NEW CINGULAR WIRELESS PCS, LLC (AT&T)
PETITION FOR A DECLARATORY RULING,
PURSUANT TO CONNECTICUT GENERAL
STATUTES §4-176 AND §16-50K, FOR THE
PROPOSED MODIFICATIONS TO AN EXISTING
WIRELESS TELECOMMUNICATIONS FACILITY
AT THE SIMSBURY VOLUNTEER FIRE
DEPARTMENT LOCATED AT 345 BUSHY HILL
ROAD, SIMSBURY, CONNECTICUT.

PETITION NO. 1373

AT&T's RESPONSES TO SITING COUNCIL INTERROGATORIES
SET ONE

Natural Diversity Data Base Areas

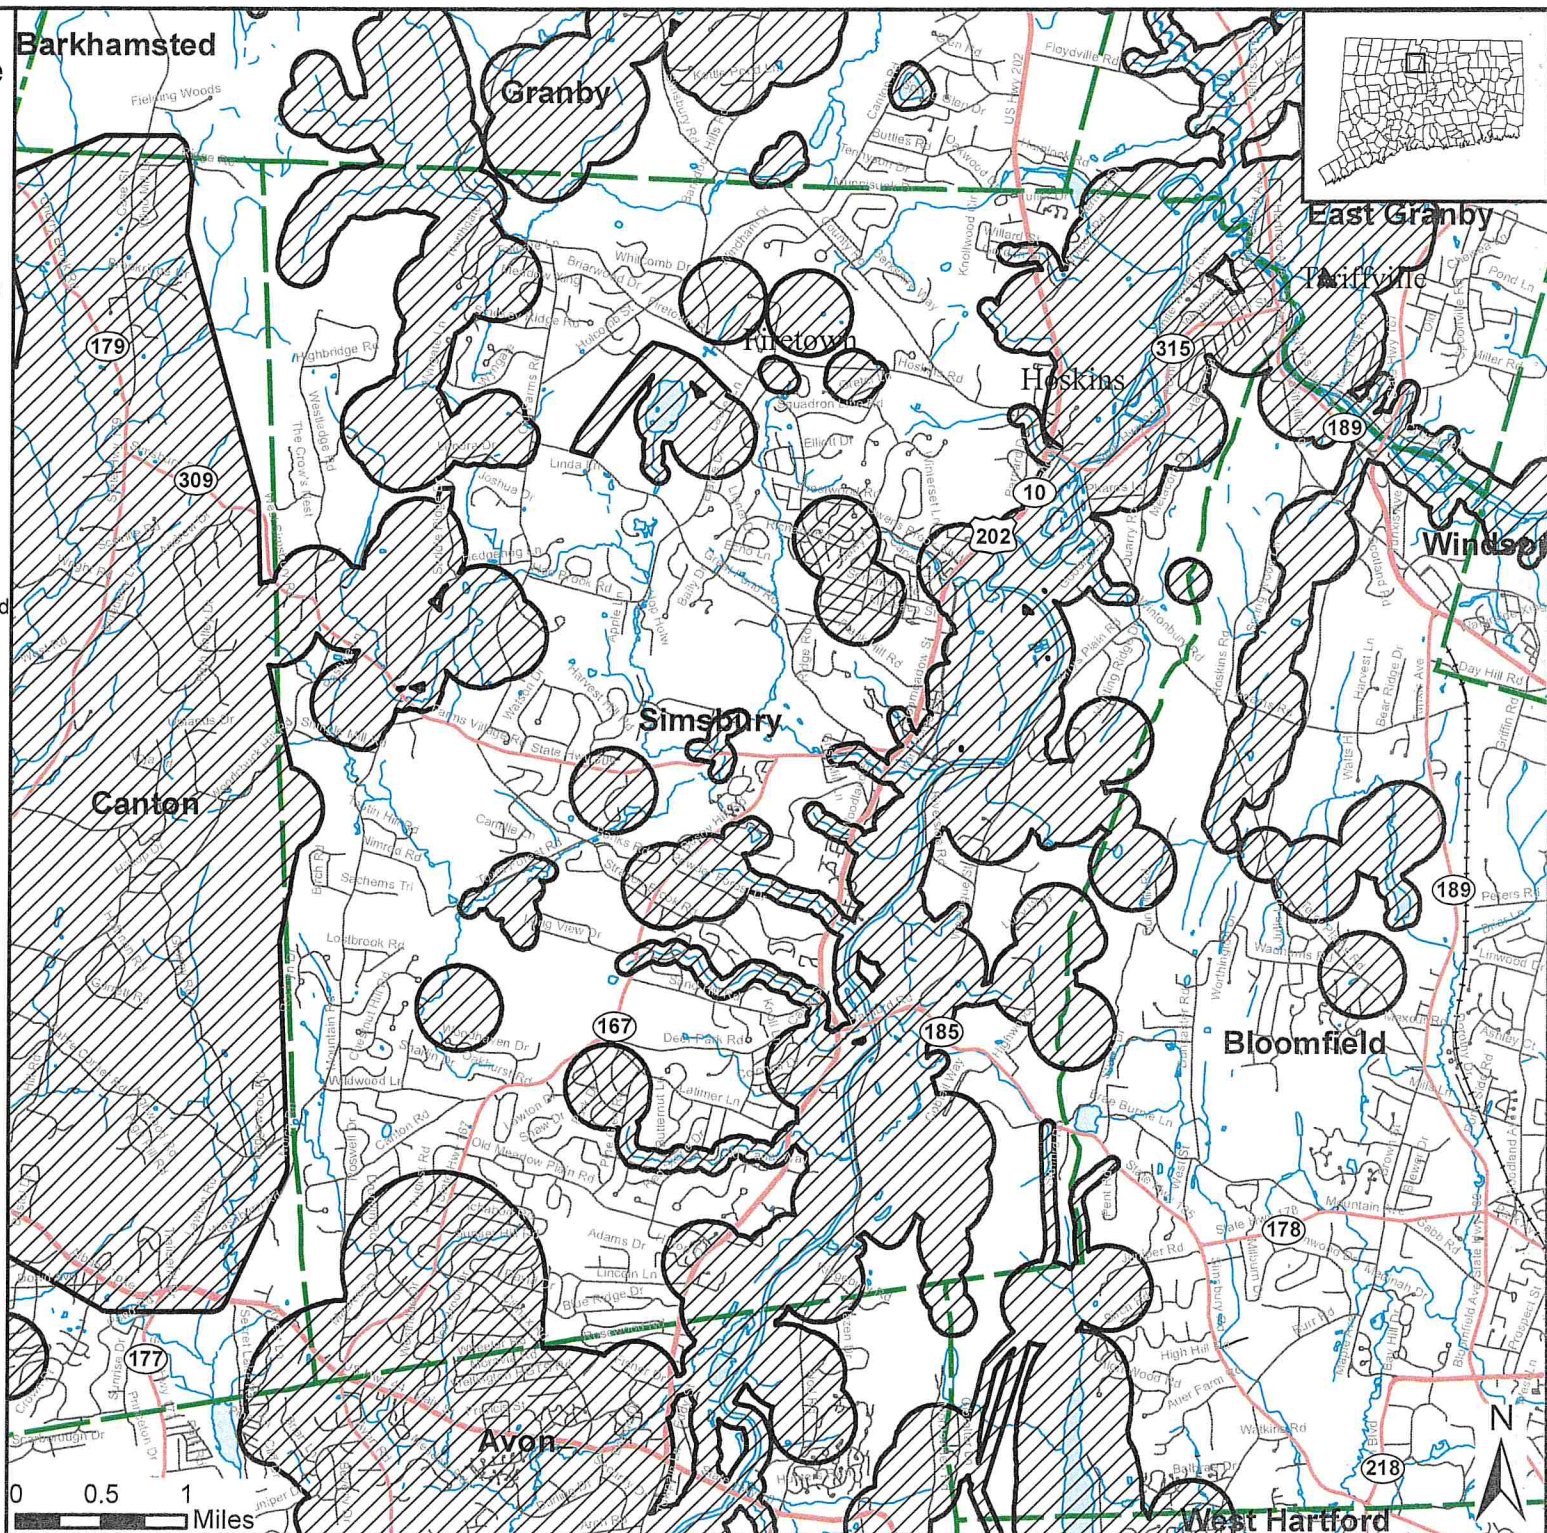
- Q8. Is the work area within a Department of Energy and Environmental Protection mapped Natural Diversity Database area?
- A8. *No, the work area is not within a CT Department of Energy and Environmental Protection ("CT DEEP") mapped Natural Diversity Database area. Please refer to the enclosed CT DEEP Natural Diversity Database Areas map, dated December 2013, with the site location identified. A more recent search using the currently available December 2018 CT DEEP Natural Diversity Database Areas map demonstrates that there have been no changes to the natural diversity areas near the approximate site location. See the enclosed December 2018 CT DEEP Natural Diversity Database Areas map.*

SHEET NUMBER:
Z-1

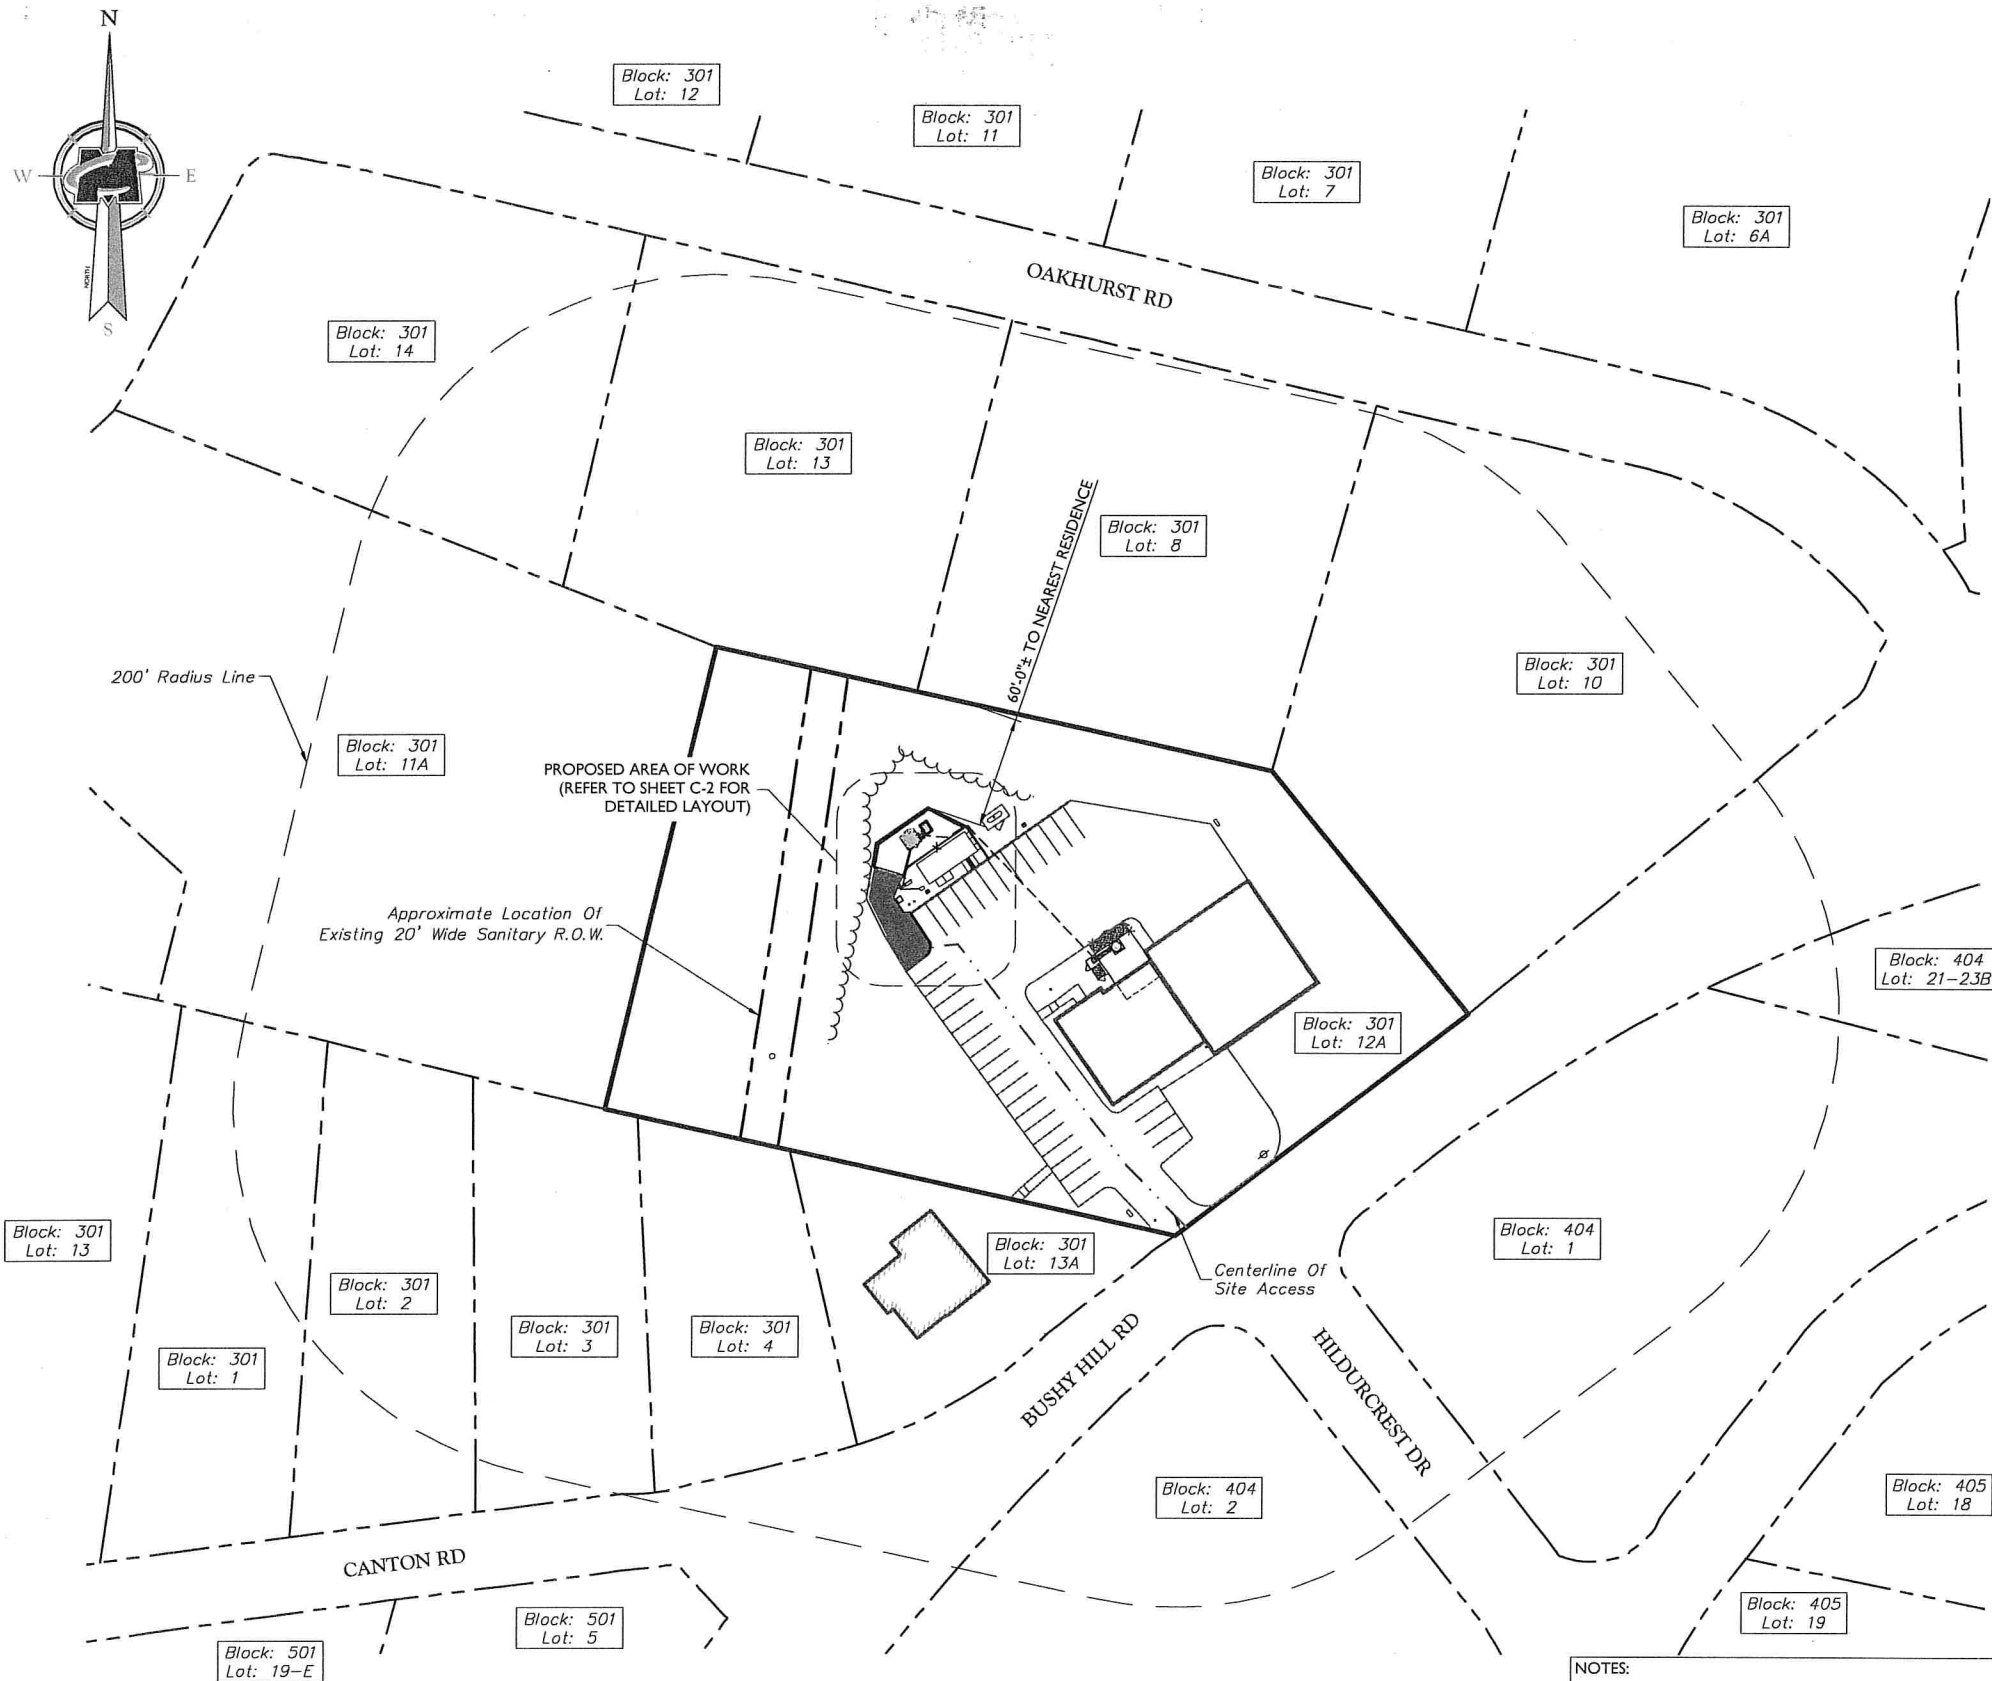
Q2. Site Plan Z-1 indicates the nearest residence to the compound retaining wall but the referenced "residence" appears to be a fire department building. What is the distance from the proposed retaining wall to the nearest residential property line?

- *Sheet Z-1: Revised distance to nearest residential property line and added shaded area for proposed access drive;*
- *Sheet Z-2: Include proposed area of access drive, added notes about total fill needed and proposed tree removal; and*
- *Sheet Z-6: Proposed chain link fence detail added.*

A2. *The nearest residential property line is approximately 60 feet from the proposed compound retaining wall. Please refer to Sheet Z-1 of the enclosed Site Drawings prepared by Maser Consulting Connecticut, dated April 9, 2019 and last revised July 22, 2019 ("Revised Site Drawings"). The nearest residential property is located at 9 Oakhurst Road (Tax Lot # C16-301-008).*

SHEET NUMBER:
Z-2

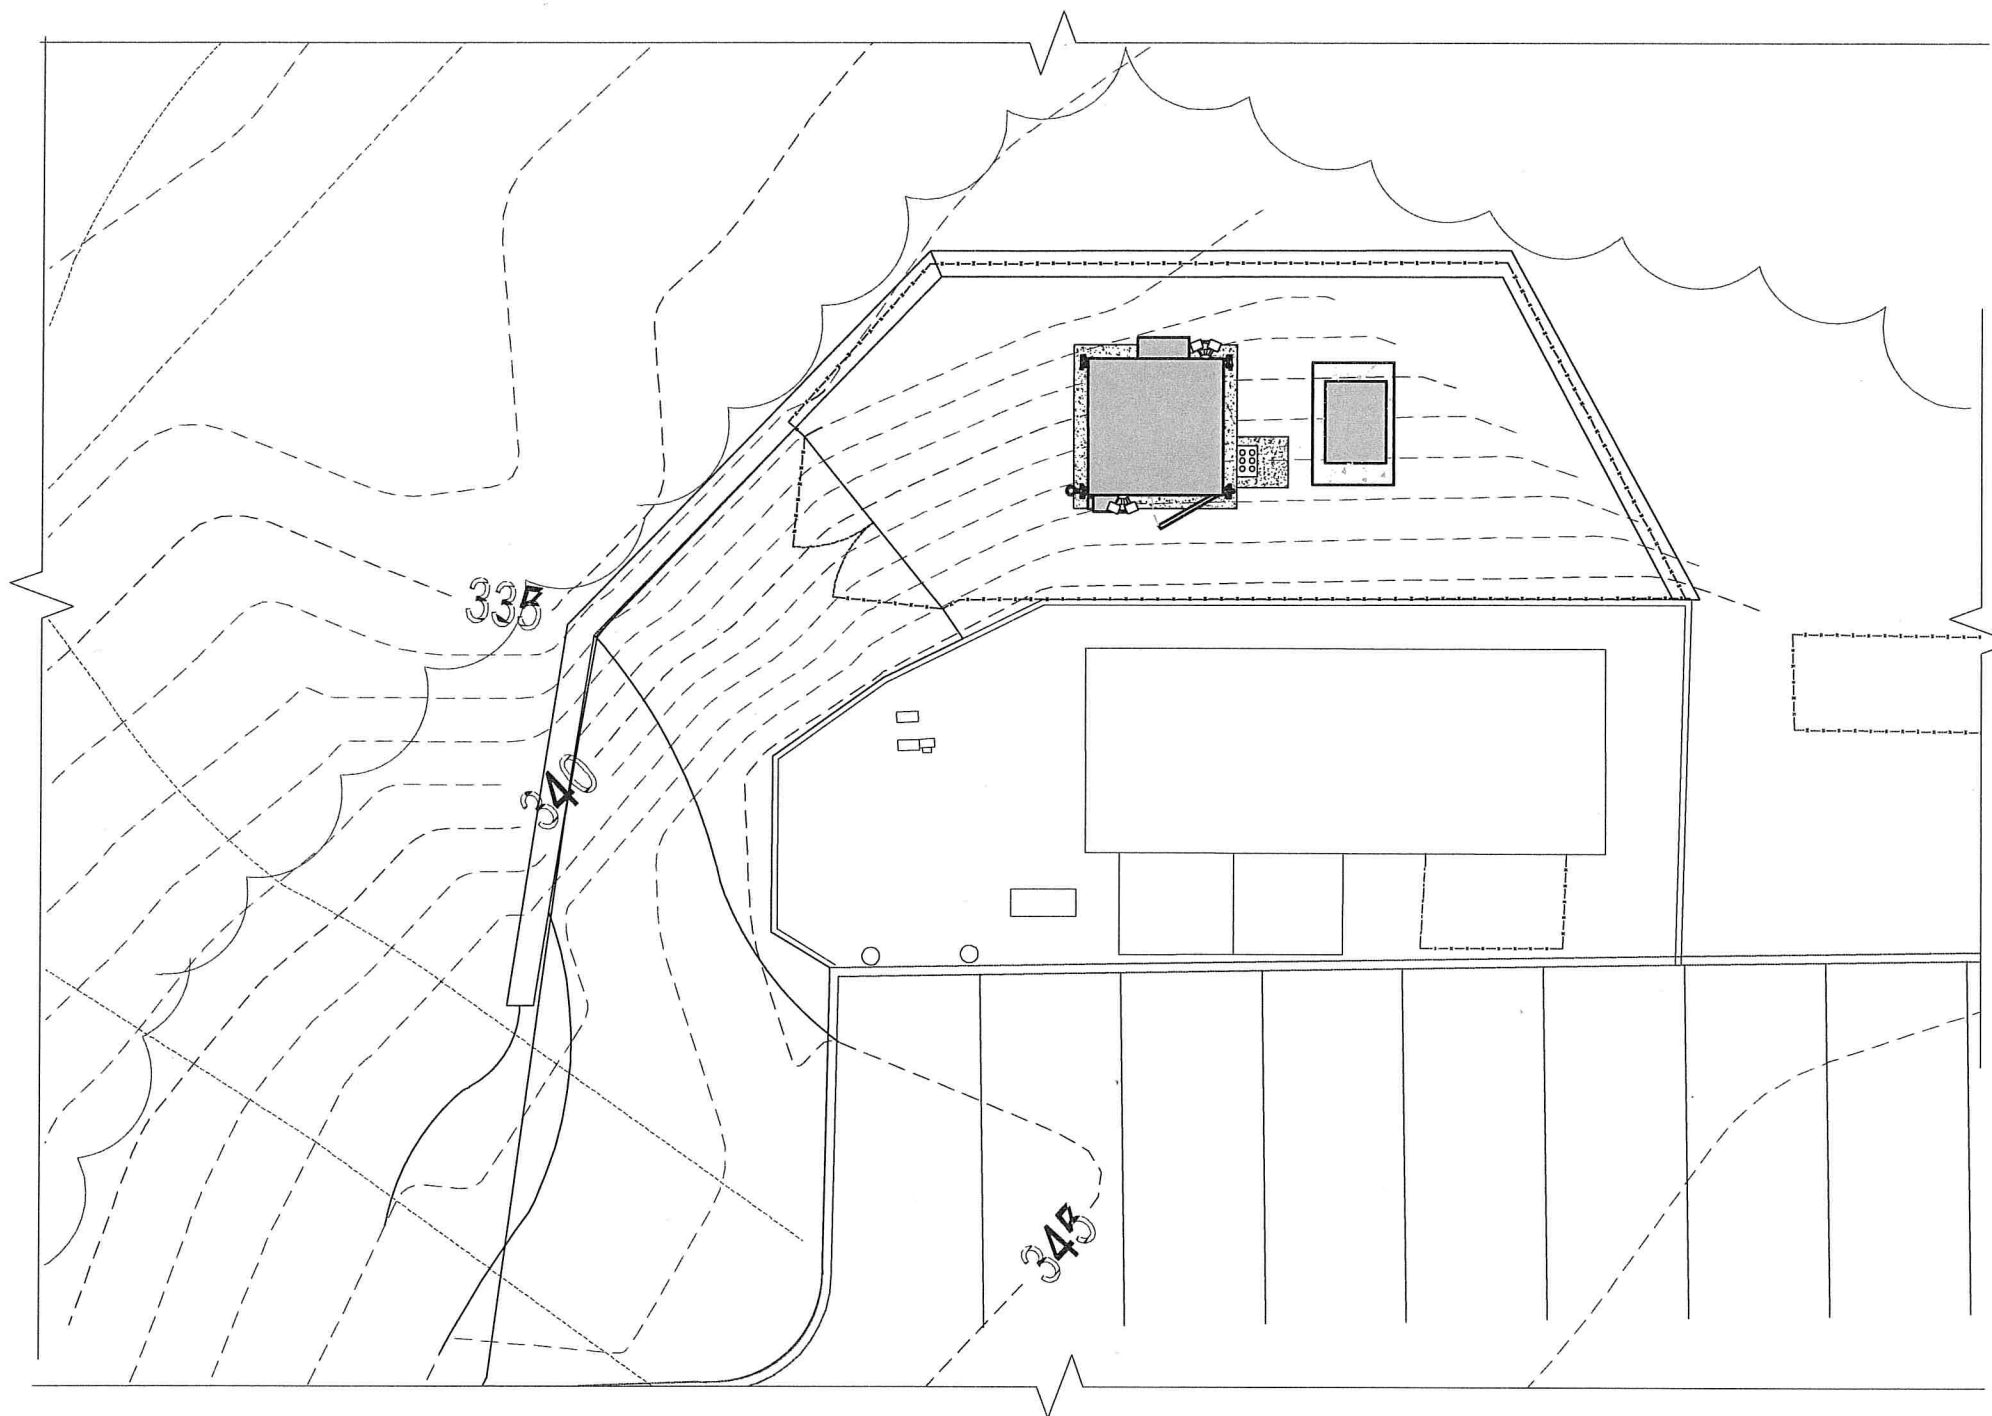
Q3. Provide detail for the proposed access drive. What is the maximum height of the access drive retaining wall? Are any pedestrian/vehicle safety rails or barriers proposed at the top of the wall?

A3. *Please refer to Sheet Z-2 of the attached Revised Site Drawings for details of the proposed access drive. The 60-foot long access drive will be located to the southwest of the compound and will measure approximately 14 feet wide.*

The maximum height of the access drive retaining wall will be 9.7 feet. While the retaining wall will be a total of 11.7 feet high, only 9.7 feet will be exposed. A 6-foot chain link fence

will be installed around the proposed equipment compound and along the top of the wall. No additional barriers or safety rails are proposed. Please refer to Sheets Z-2, Z-4, Z-5 and Z-6 of the enclosed Site Drawings for details of the proposed retaining wall and chain link fence.
